**DEPARTMENT OF TRANSPORTATION****Federal Aviation Administration****14 CFR Part 36**

[Docket No. FAA-2000-7958; Amendment No. 36-25]

**Noise Certification Regulations for Helicopters**

ACTION: Final rule.

#### *Figures H1, H2 and H3*

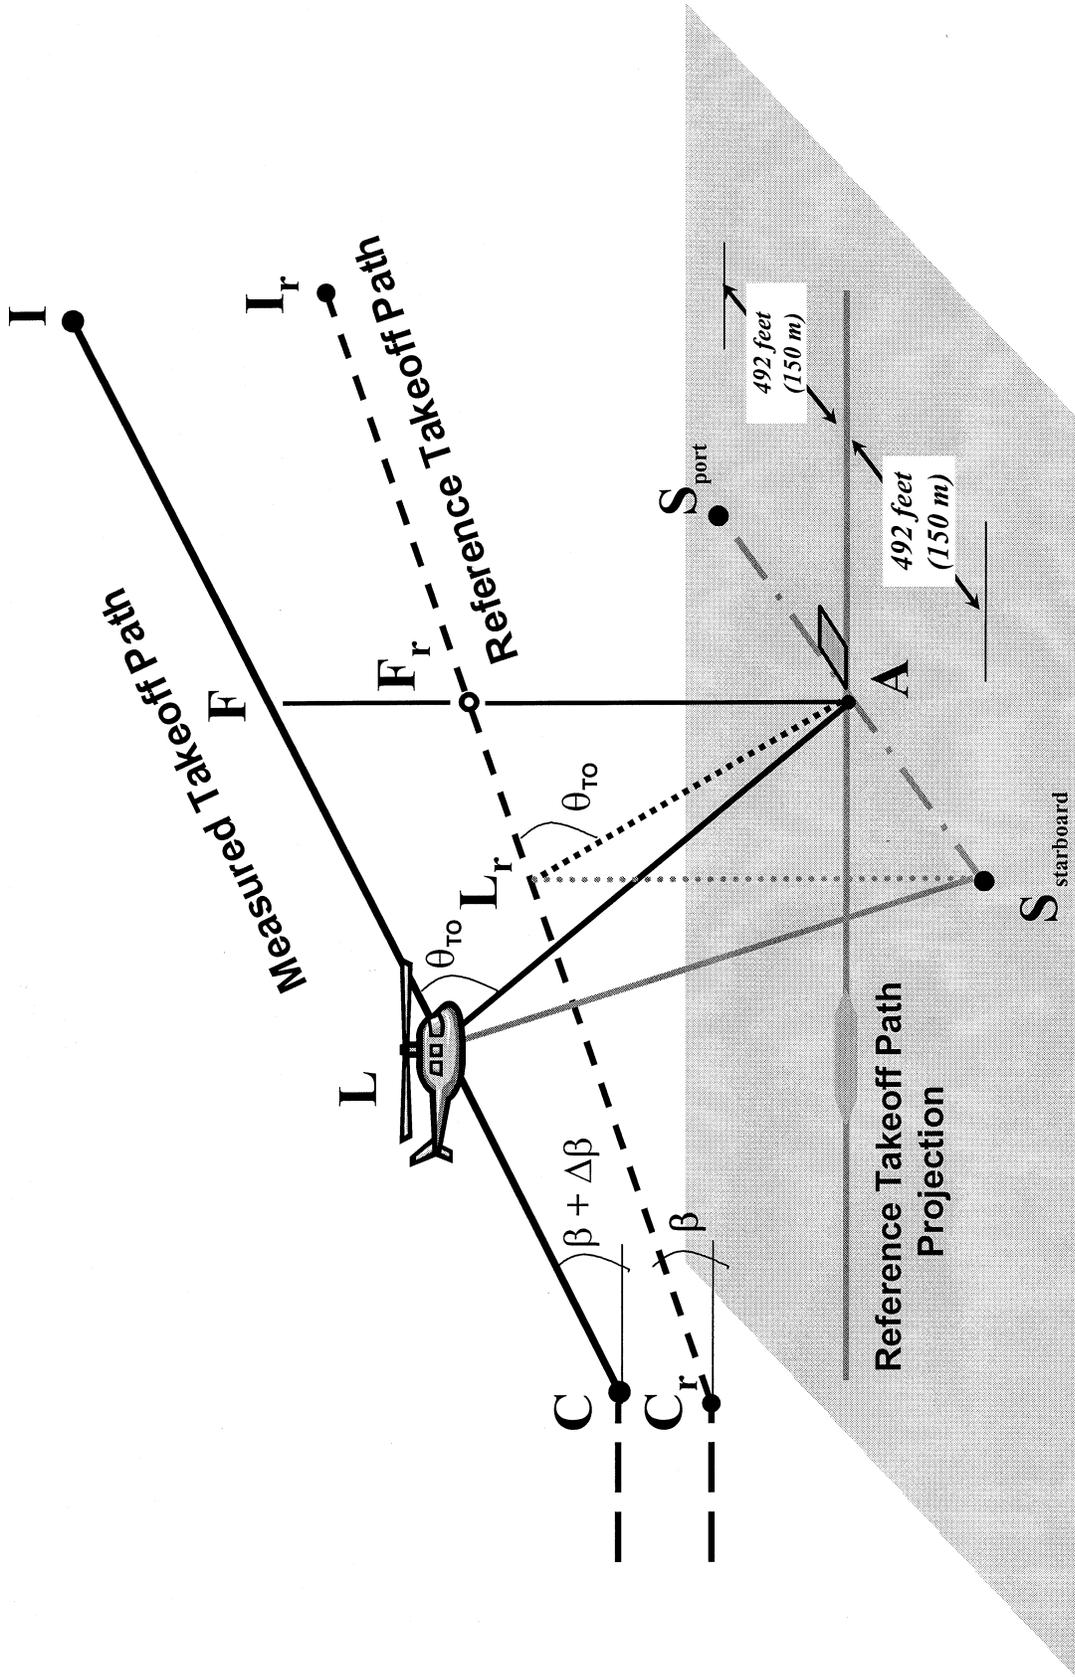
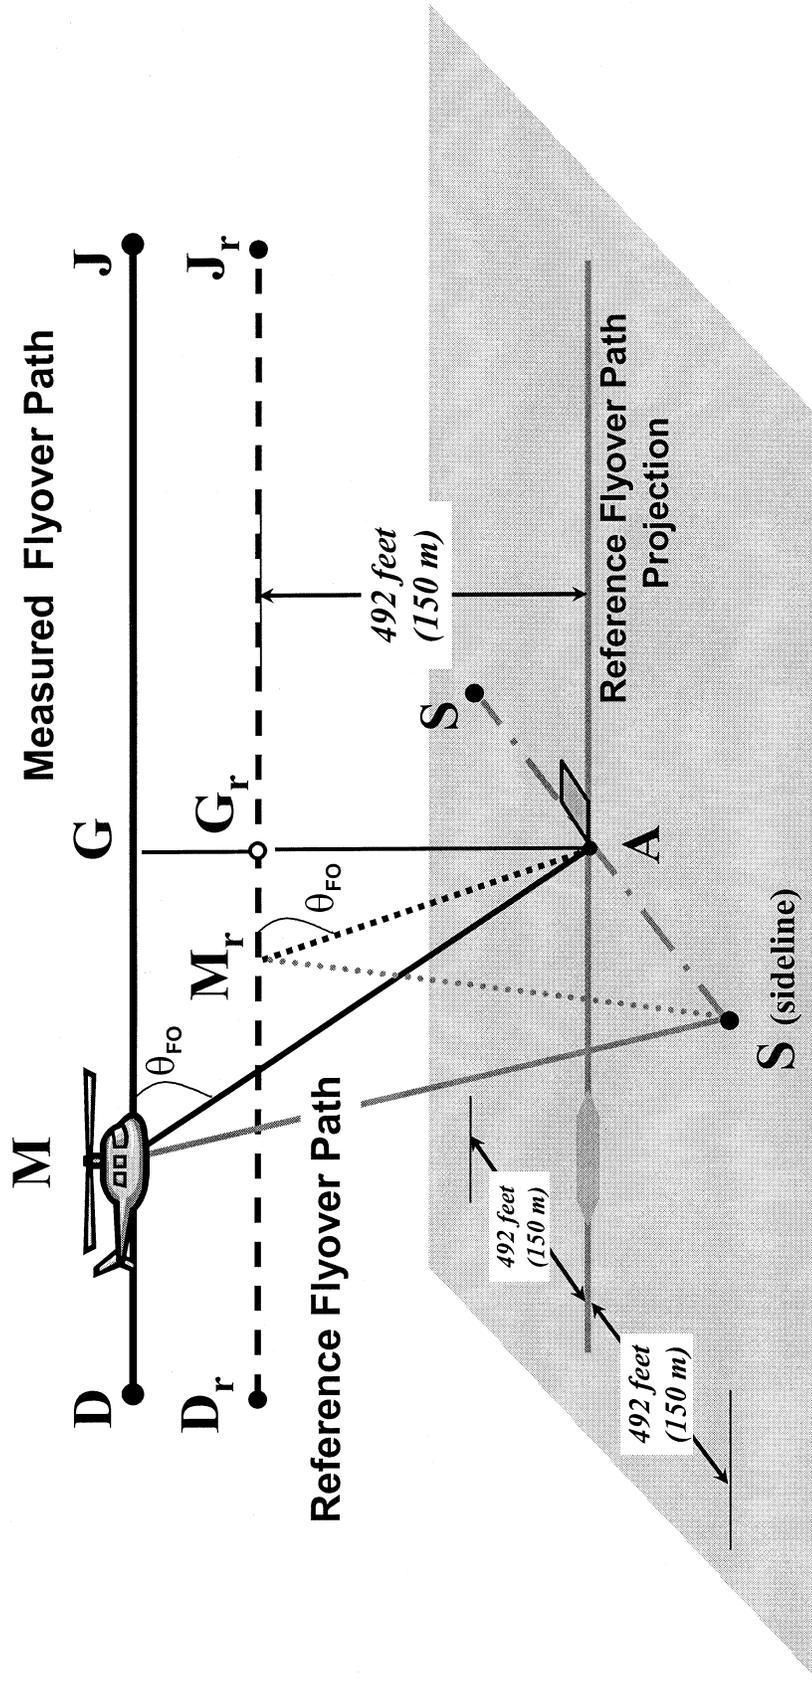
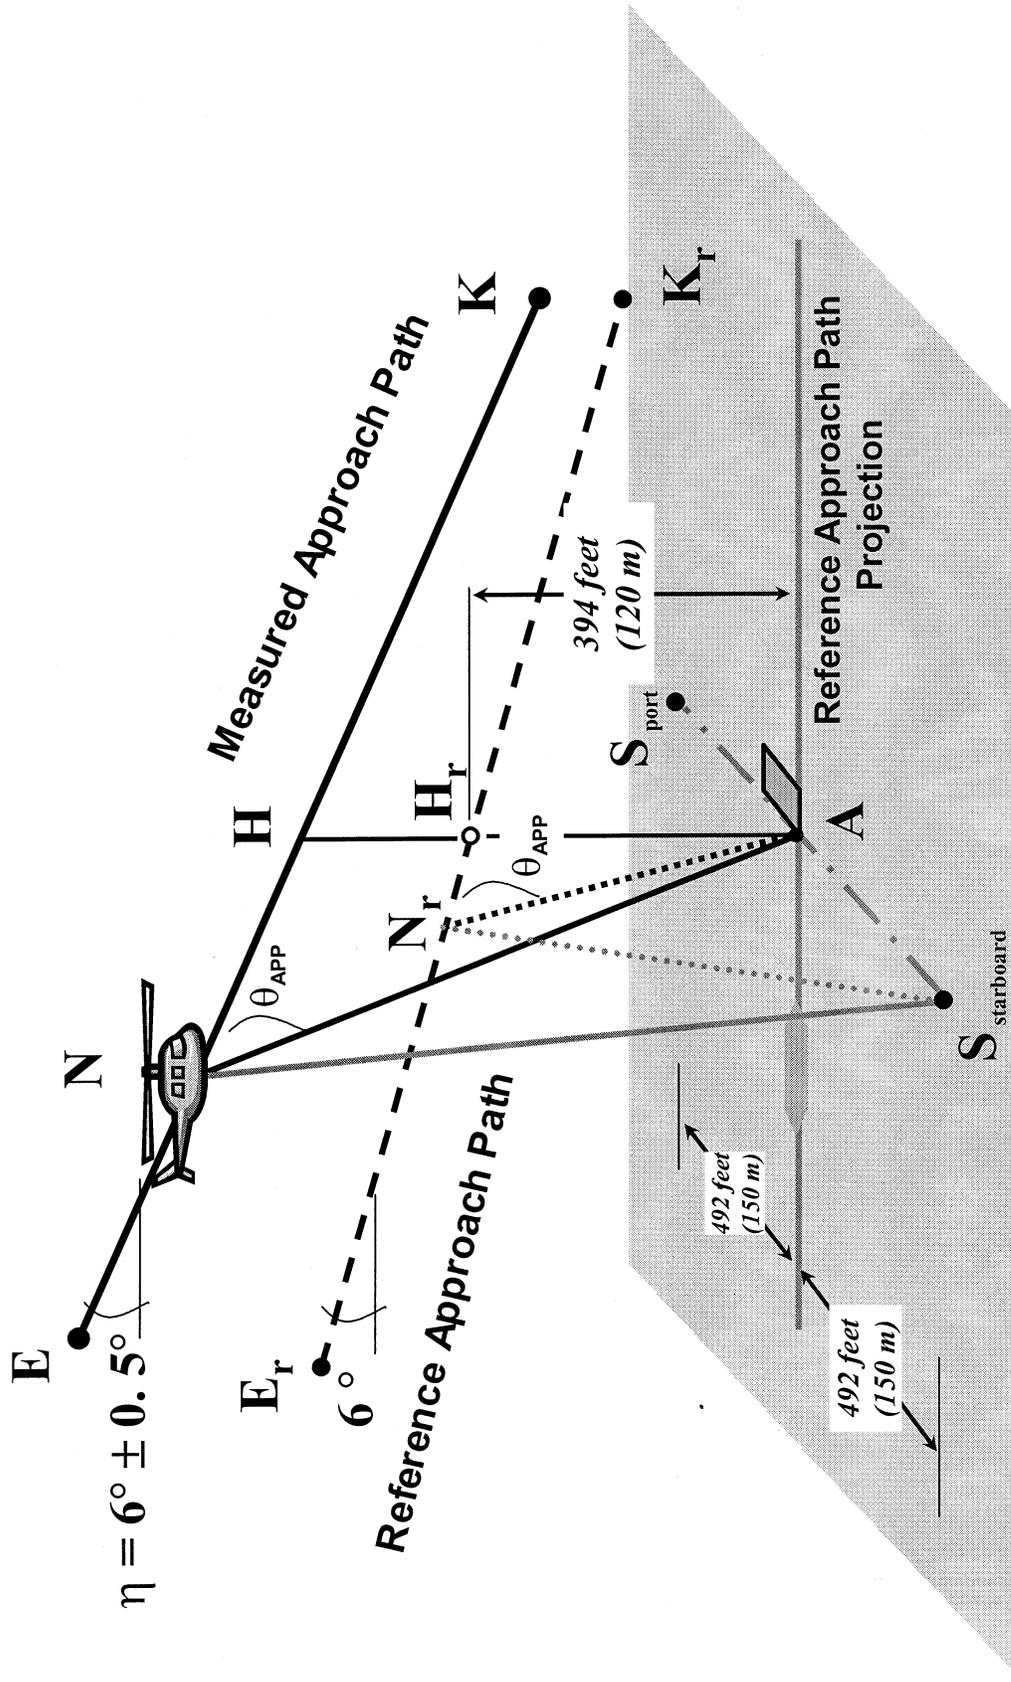
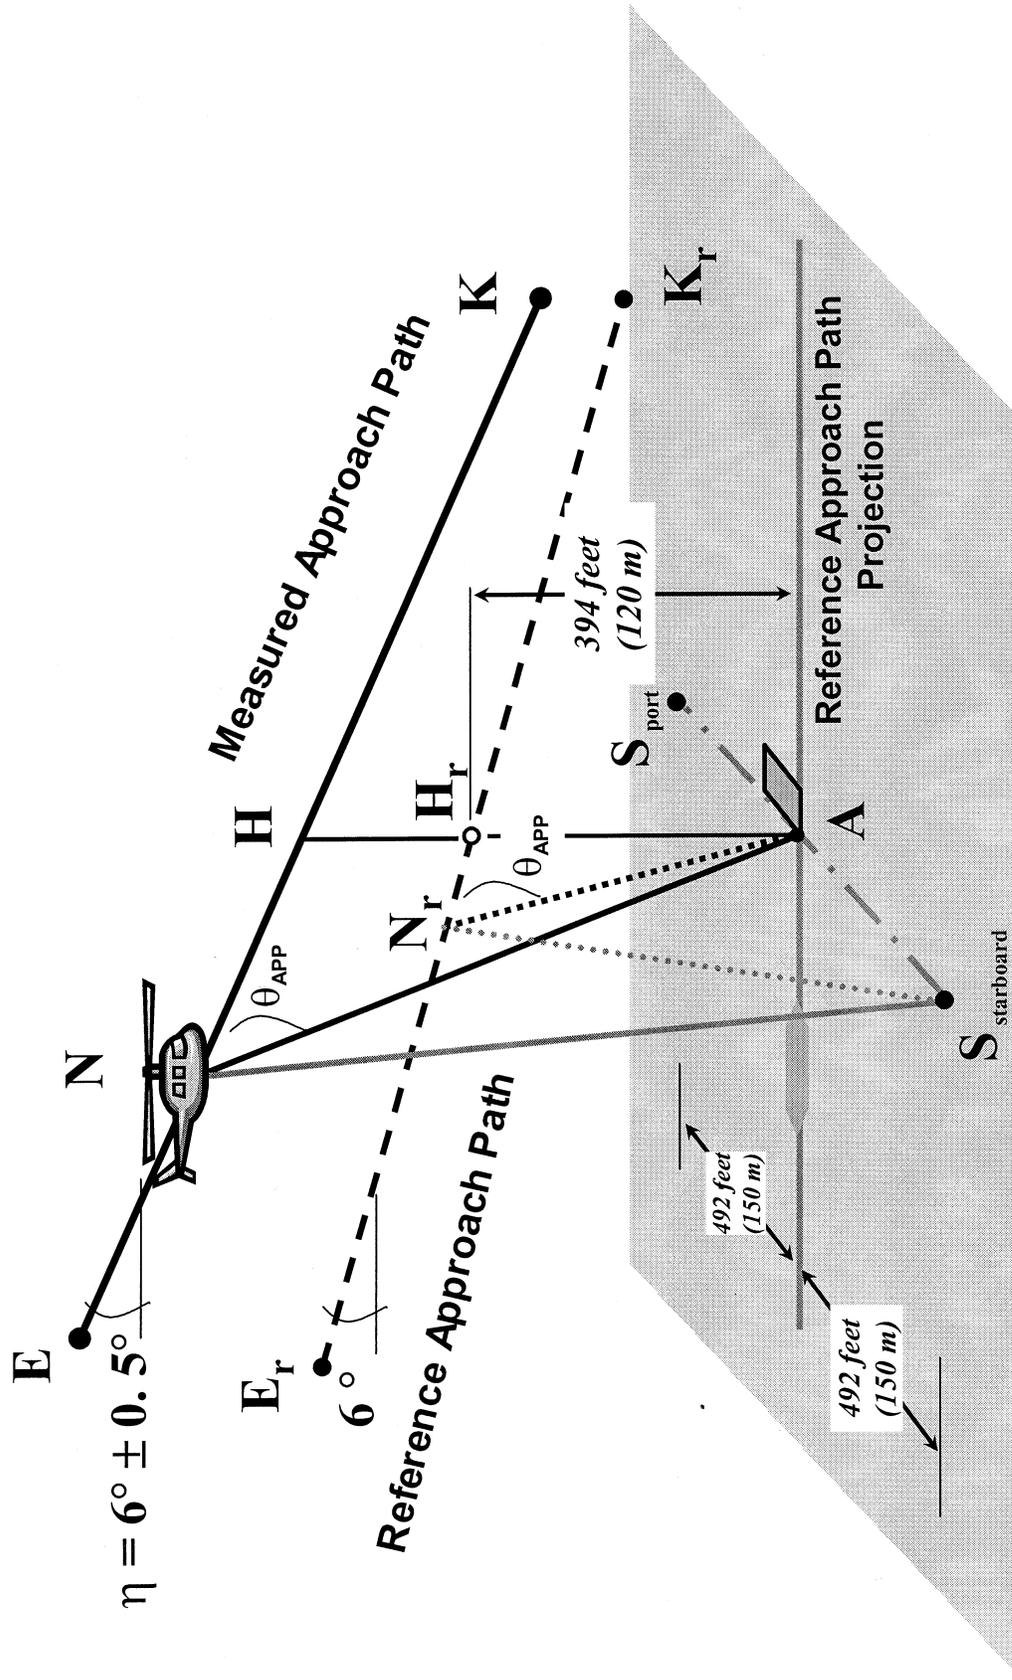
In Notice No. 00-12, the FAA proposed to revise Figures H1 and H3 to include the height above measurement points in metric units and to delete the closest point of approach (CPA) distance designations. The FAA received no comments on this proposal and it is being adopted as proposed.

Although Figure H2 changes were not addressed in the NPRM, for accuracy and completeness, the FAA is making corrections to typographical errors and replacing incomplete designations. The word "corrected" is replaced with the

word "reference" in the titles of Figures H1, H2 and H3 in the final rule. This change keeps the language in the final rule consistent throughout Appendix H.
